# Access Compliance Report

## Public Rights-of-Way

Intersection ID: 10020275	Main Street: AYRSLEY_TOWN_BV	Cross Street: N/A	Location: SW
ADA ID: 2DA70C292D4D	Ramp Type: BlendTrans2	Initial Pass/Fail: Pass	Overall Compliance: No
			Severity Score: 0.25

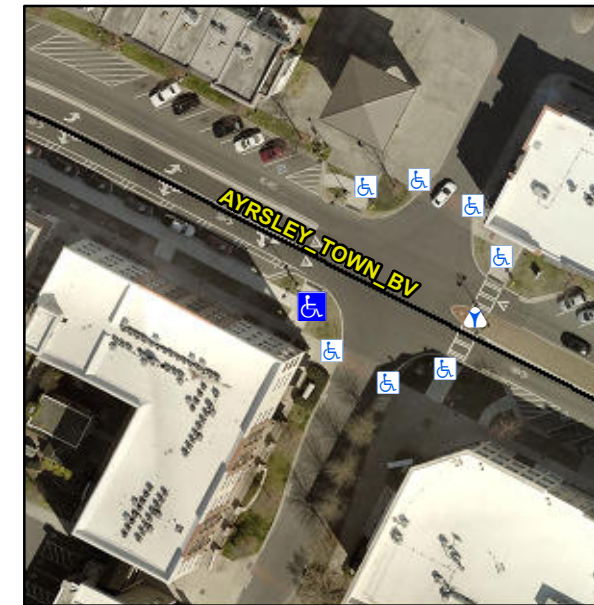
**Not Found, R304.5.3, R305.2**

Compliance	Description	Data	Compliance	Description	Data
N/A	Ramp Length (in)	120.0	Yes	BlendTrans Slope (%)	3.6
Yes	Ramp Width (in)	117.0	No	BlendTrans XSlope (%)	2.6
Yes	Flare Type L	Curbed_NoWalkSurface	Yes	Flare Type R	Curbed_NoWalkSurface
N/A	Flare Slope LT (%)	N/A	N/A	Flare Slope RT (%)	N/A
N/A	Flare Traversable LT?	No	N/A	Flare Traversable RT?	No
N/A	Landing Length (in)	N/A	Yes	DWS Provided?	Yes
N/A	Landing Width (in)	N/A	Yes	DWS Contrast?	Yes
N/A	Landing Slope (%)	N/A	Yes	DWS Length (in)	24.0
N/A	Landing X Slope (%)	N/A	Yes	DWS Full Width?	Yes
N/A	Landing Curb? (Y/N)	No	No	DWS Offset (in)	2.5
N/A	Shared Landing?	No			
Yes	Gutter Ponding?	No	Yes	Gutter Slope (%)	2.9
Yes	Gutter Lip Ht (in)	0.0	Yes	Gutter X Slope (%)	1.9
N/A	Painted X Walk1?	No	N/A	Painted X Walk2?	N/A
	X Walk 1 Direction	To N		X Walk 2 Direction	N/A
	X Walk 1 Width (in)	N/A		X Walk 2 Width (in)	N/A
	X Walk 1 Slope (%)	2.0		X Walk 2 Slope (%)	N/A

**Remove & Replace Curb Ramp With Two New Directional Ramps or Equivalent.**
